DESIGNER	JAL
REVIEWER	JAH
PROJECT ID	115388
SHEET TOTAL	P.07 22

PLAN AND PROFILE - US-68
 BEGIN PROJECT TO STA. 100+10

**HISTORIC OLDTOWN
NEW INTERPRETIVE CENTER
1575 US-68, XENIA, OHIO 45385**

UTILITY PLAN

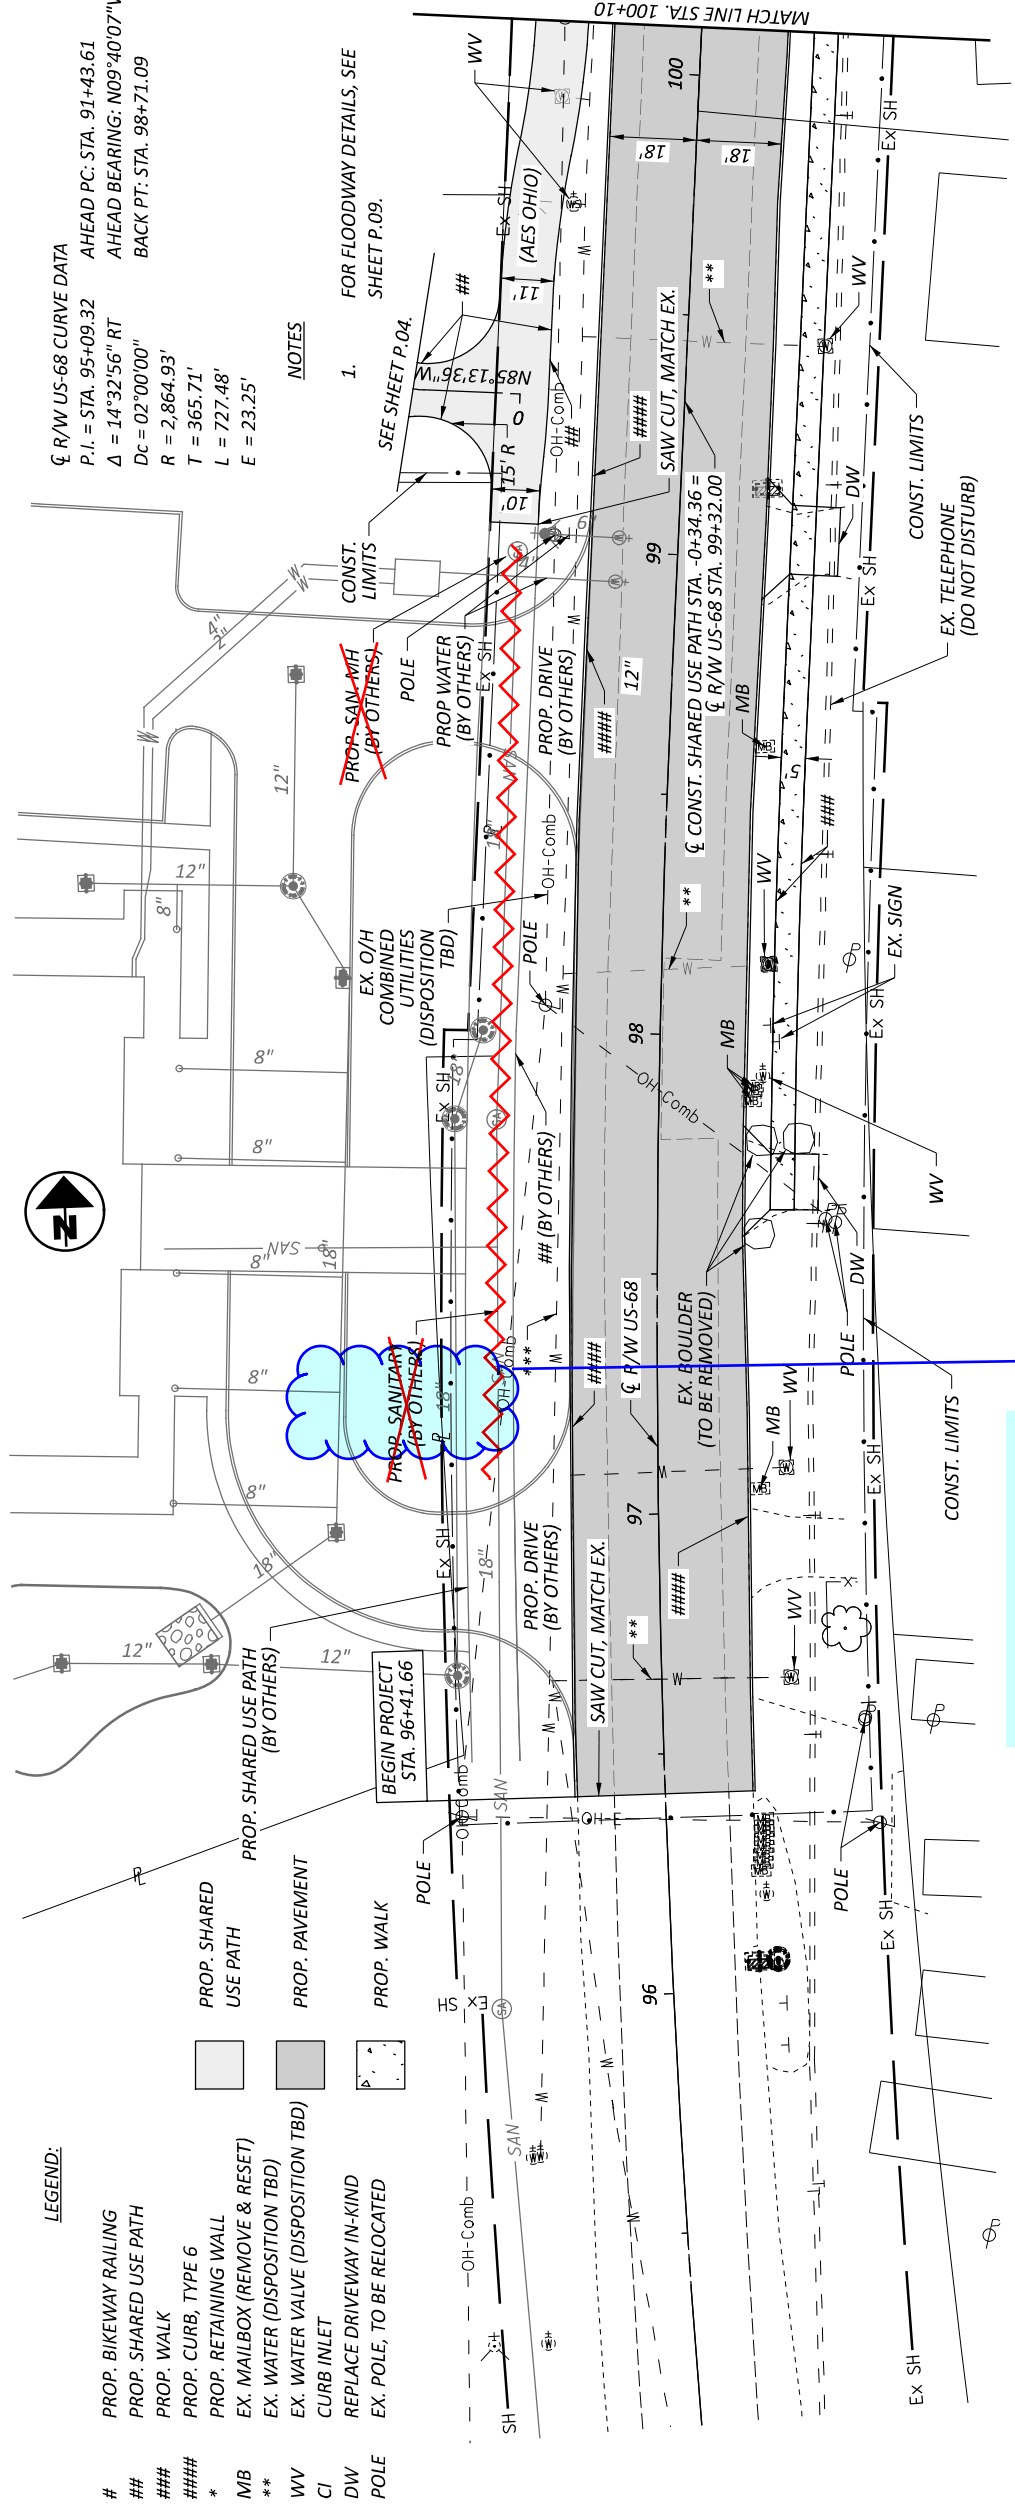
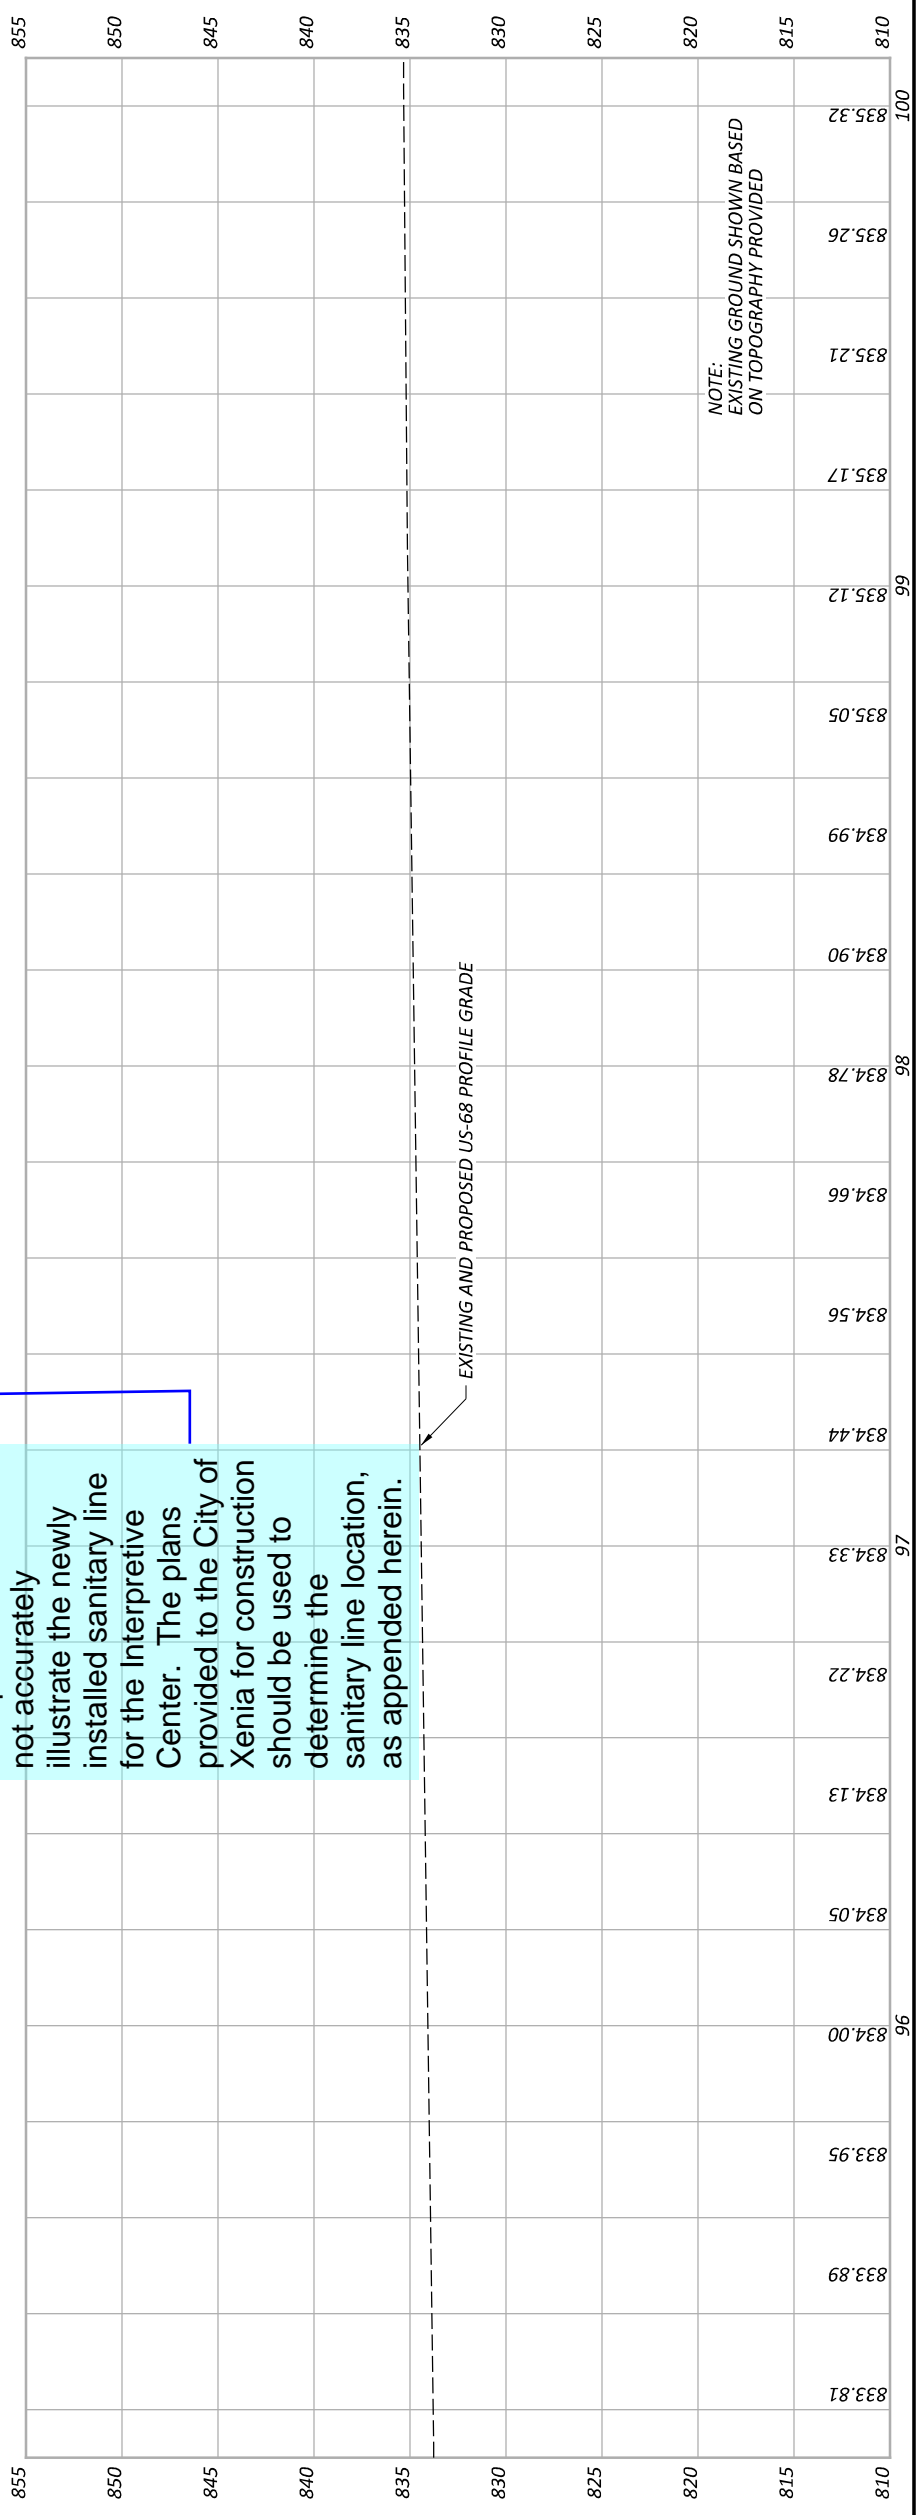
This plan sheet does not accurately illustrate the newly installed sanitary line for the Interpretive Center. The plans provided to the City of Xenia for construction should be used to determine the sanitary line location, as appended herein.
